RECORD DRAWINGS
 This drawing reflects changes from the original contract drawing that were made during construction and has been prepared from information provided to the Engineer by the construction contractor(s). The Engineer does not warrant this drawing to be complete and accurate in all respects.
 MALCOLM PIRNIE, INC.
 Date: 6/88 By: MGM

San Antonio
 WASTEWATER FACILITIES IMPROVEMENTS

CONTRACT NO. 3
DOS RIOS FACILITY
 PRIMARY SETTLING TANKS
 PLAN - TANKS NOS. 6 & 8

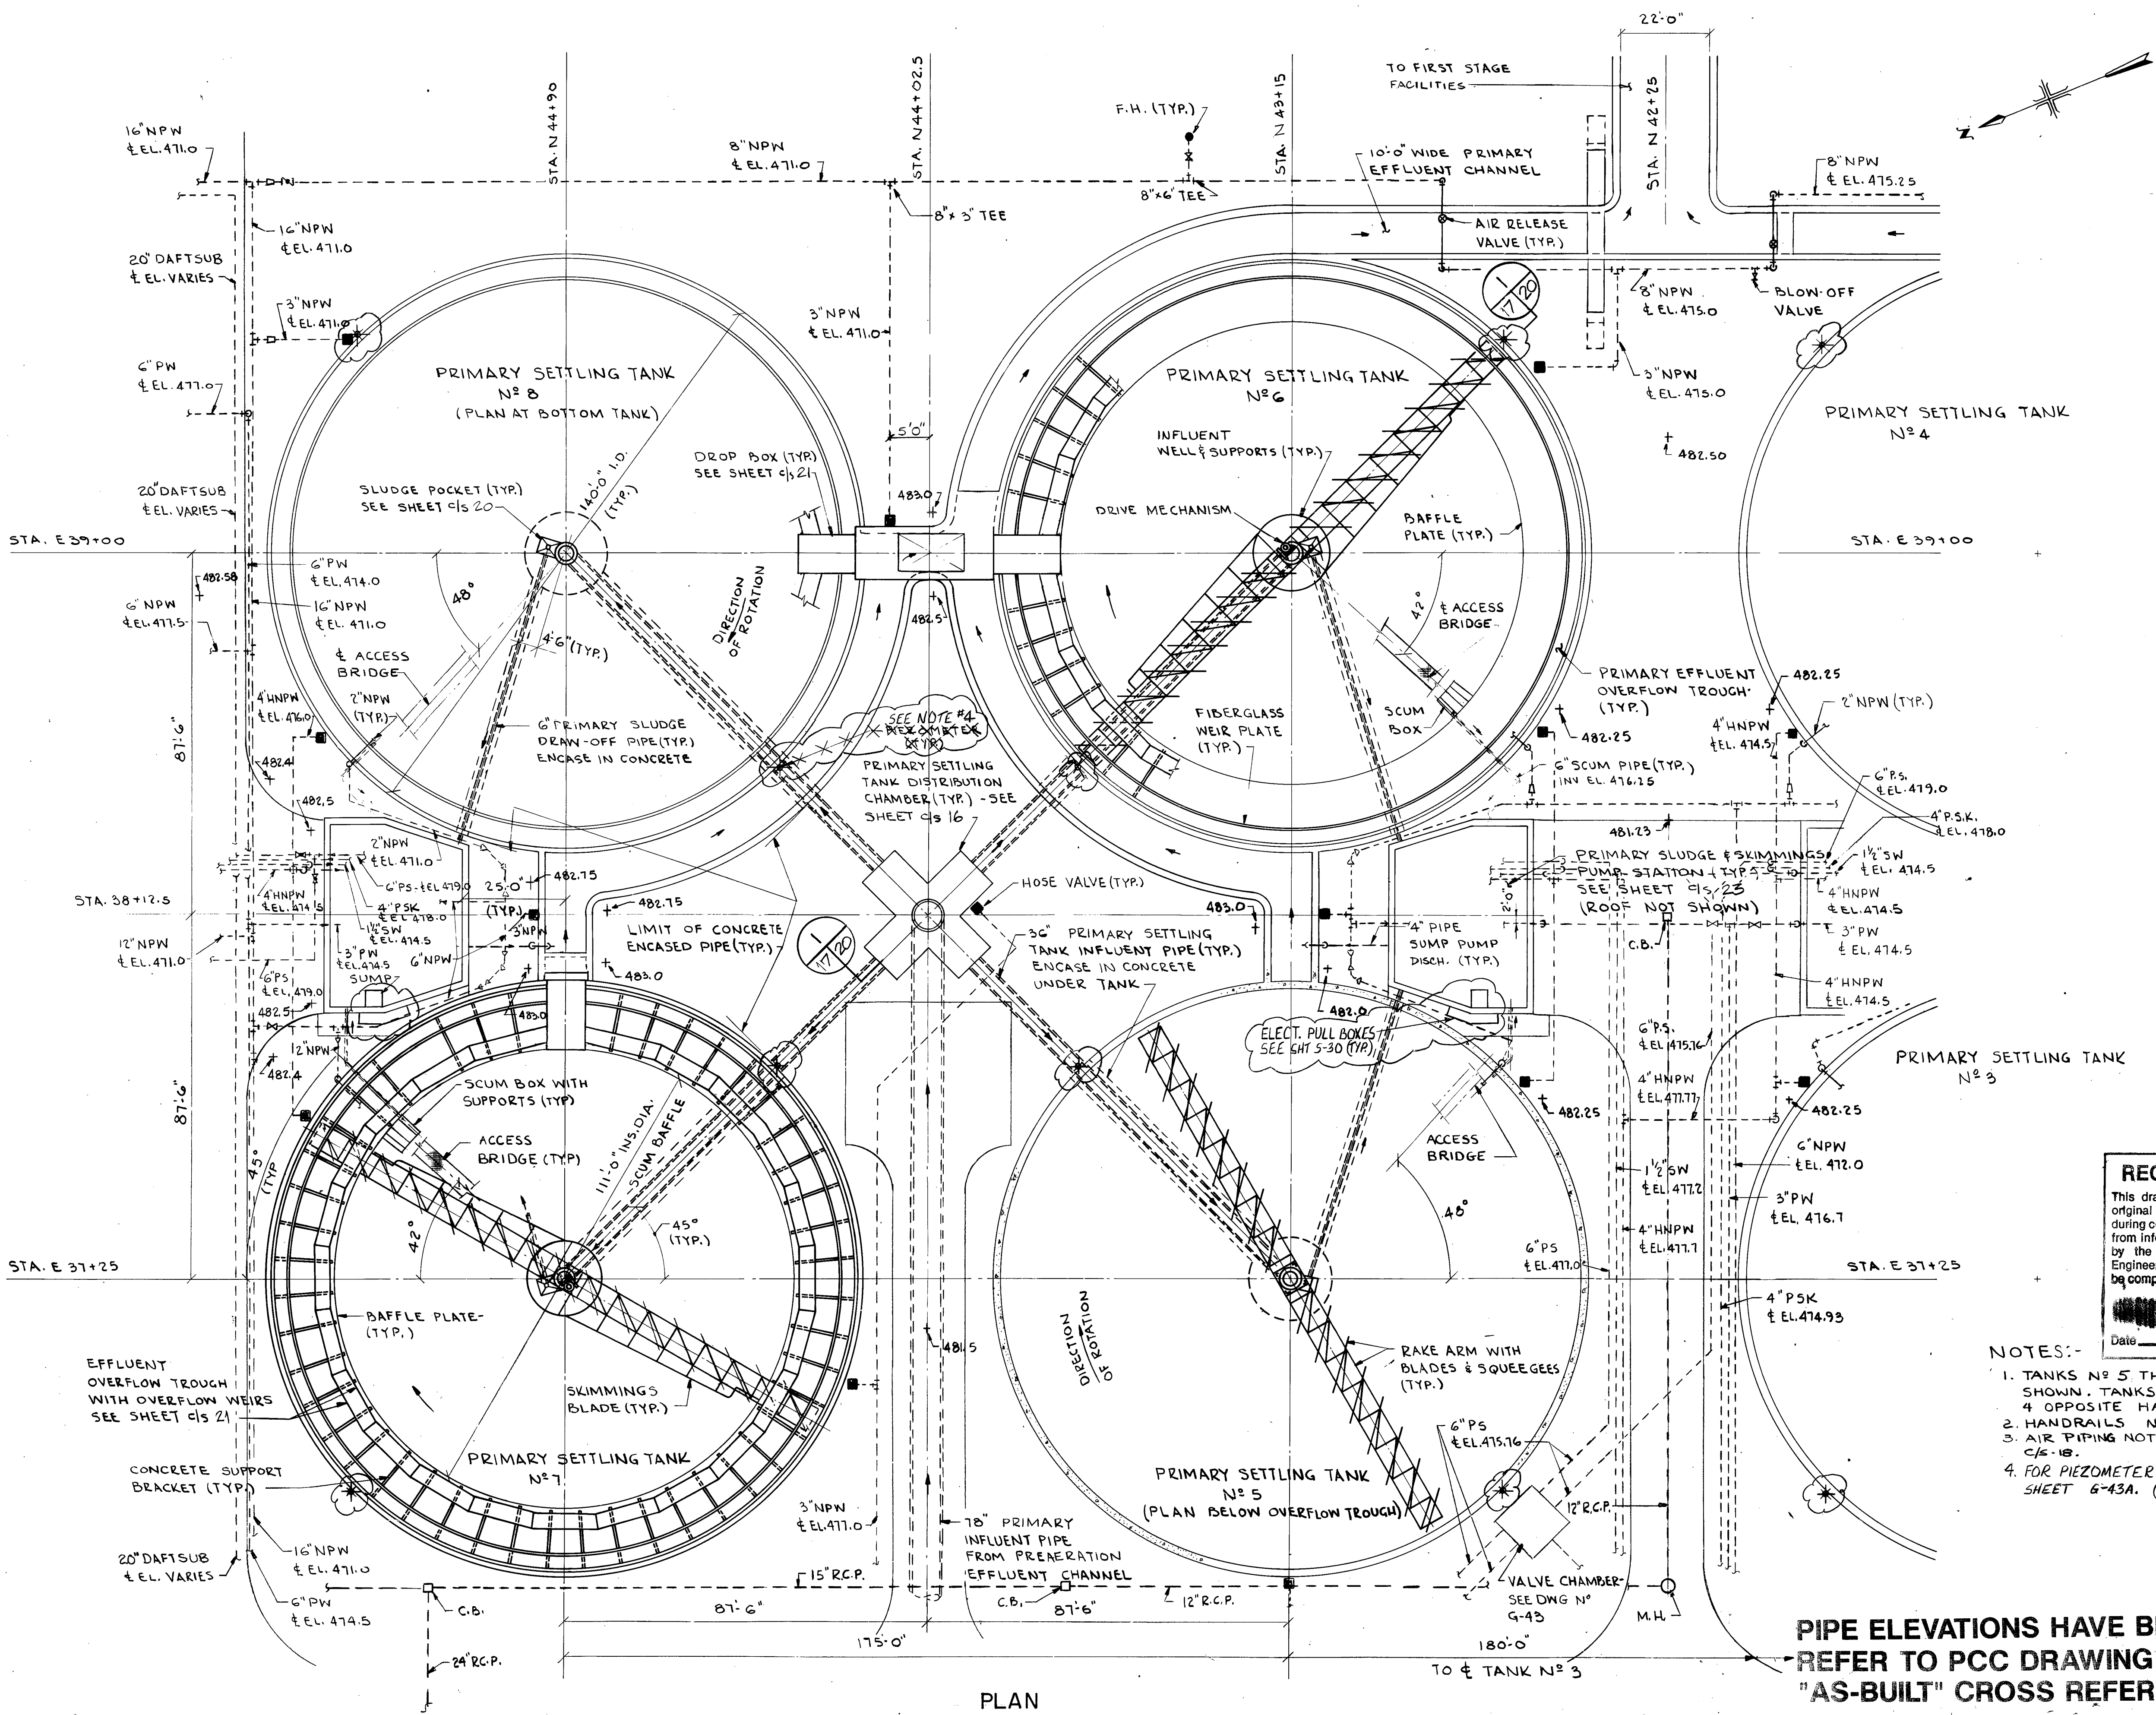
PIPE ELEVATIONS HAVE BEEN REVISED. REFER TO PCC DRAWING REF-1 FOR "AS-BUILT" CROSS REFERENCES.

Sheet C/S-18
 of C/S-66

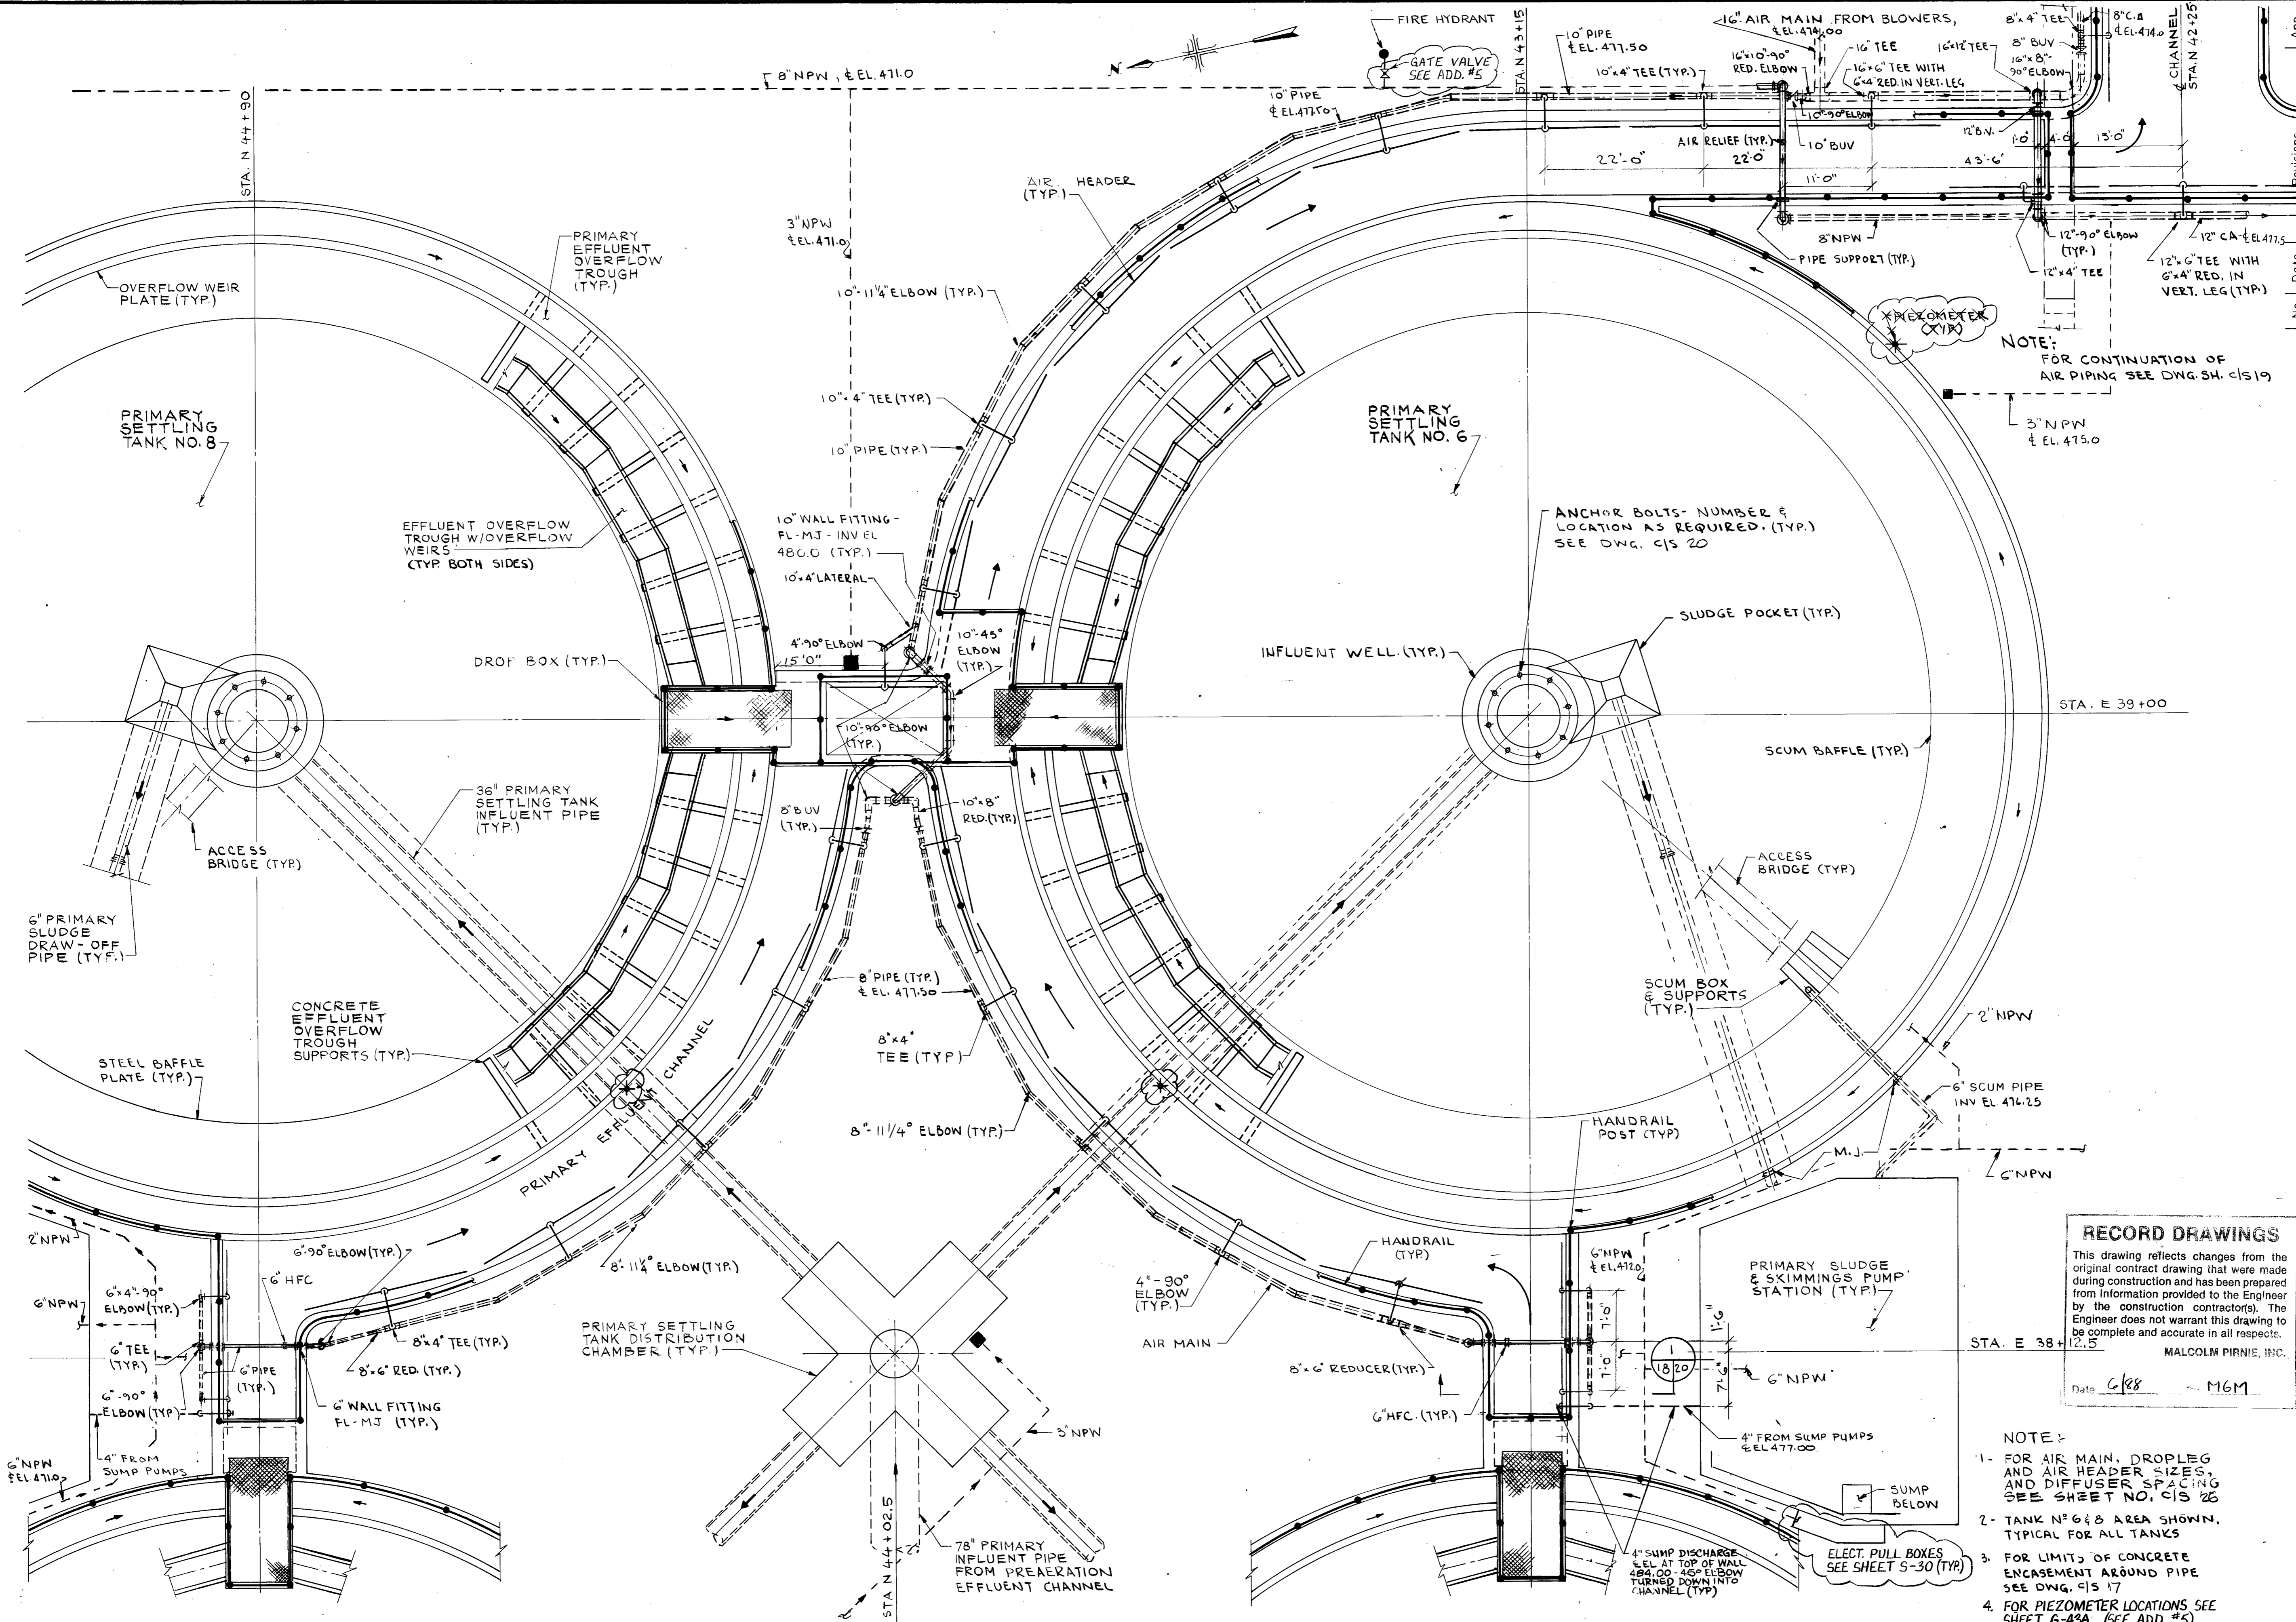
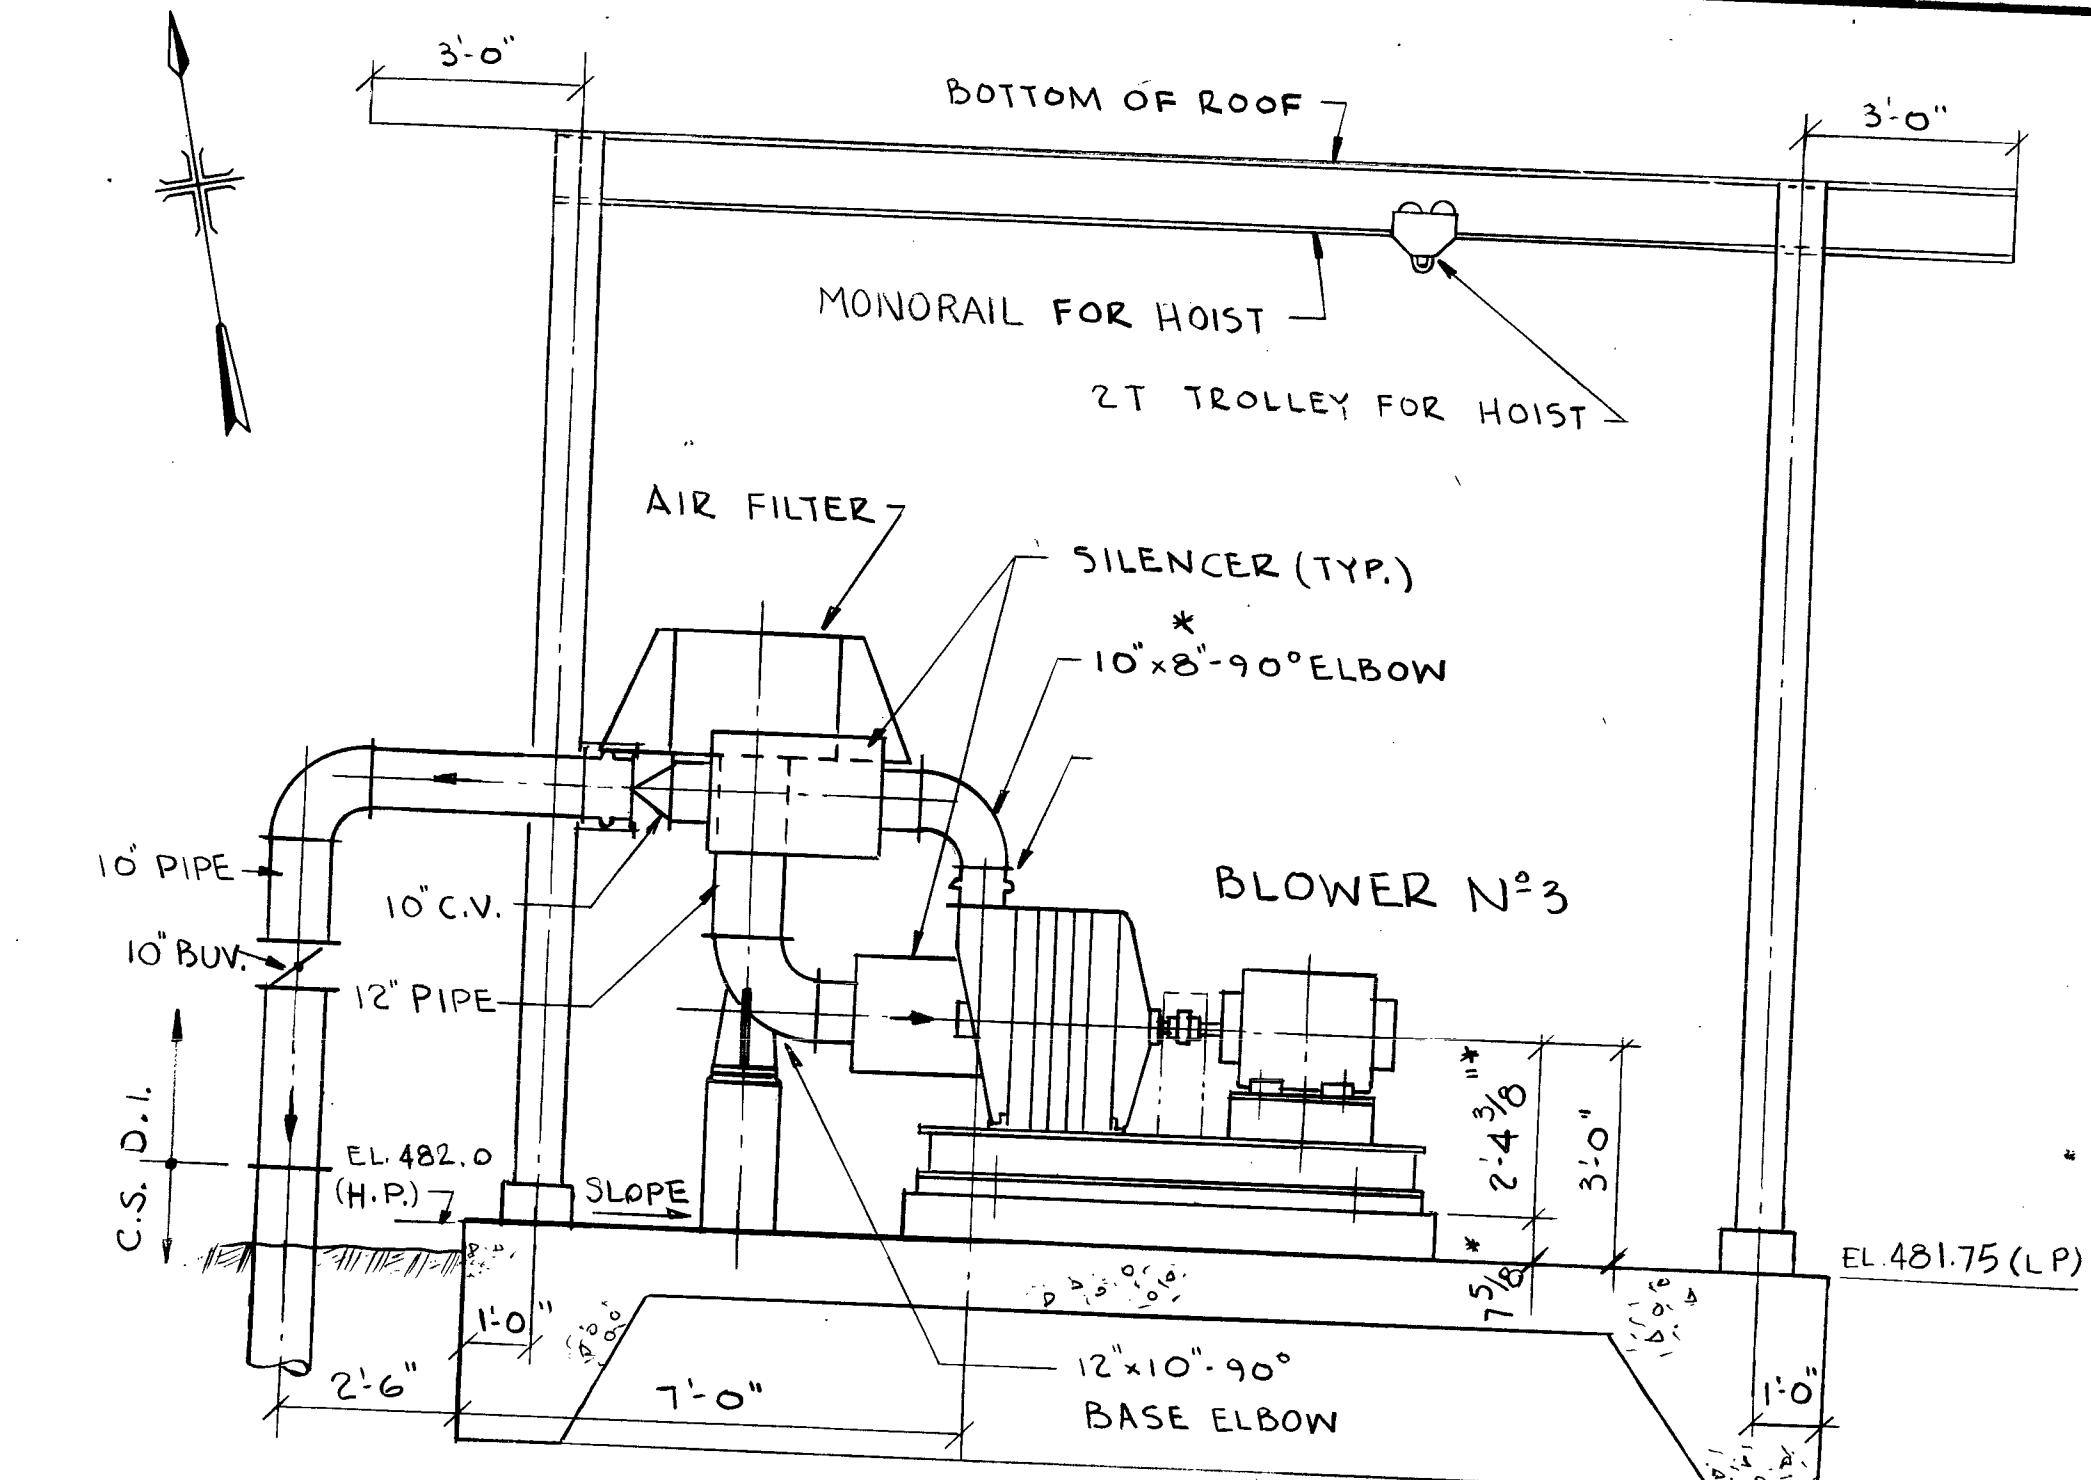
PIPE ELEVATIONS HAVE BEEN REVISED. REFER TO PCC DRAWING REF-1 FOR "AS-BUILT" CROSS REFERENCES.
